# **SPECIFIC DEFECTS REPORT**

**Independent Report in relation to  
Dampness, Cost of Work/Valuation and  
Right Hand Boundary Wall  
at**

**Redhill  
Surrey, RH1**

**FOR  
Mrs W**

Work required to window

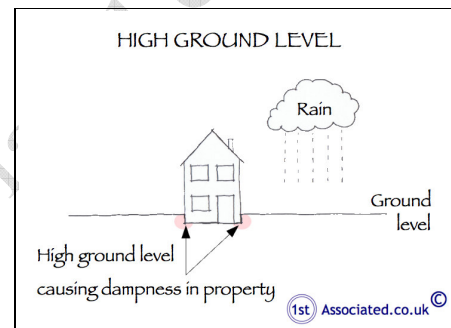
A large percentage of the major work has been completed with some areas of incomplete work, for example the oriel window to the rear (high level splayed bay window) needs work completing on it.

Shed to left hand side

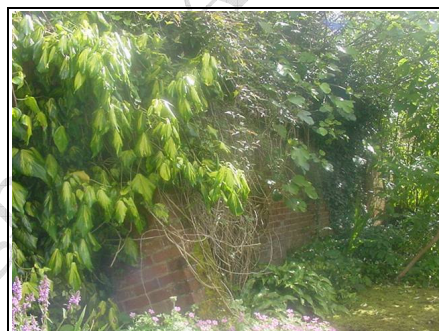
In our opinion the most acceptable way forward is to continue the work that has already been carried out in the past of adding buttresses to the wall together with some annual maintenance.

Party Fence. Not part of a building but separates different owners

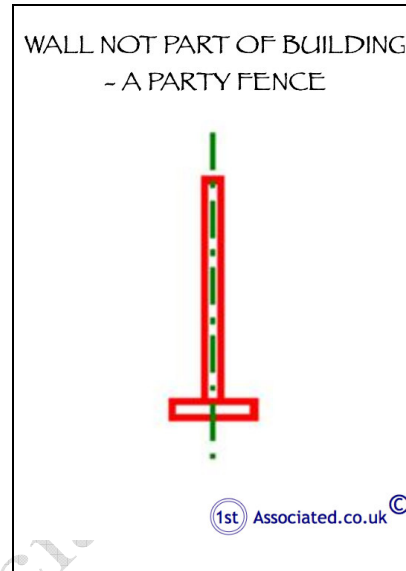
This boundary wall may be classed under the Party Wall Act 1996 as a Party Wall Fence (the technical term) and as such any work being carried out to it should fall within the Party Wall Act agreement. Any major alterations to the wall would need the appointment of a Party Wall Surveyor to agree with both parties.
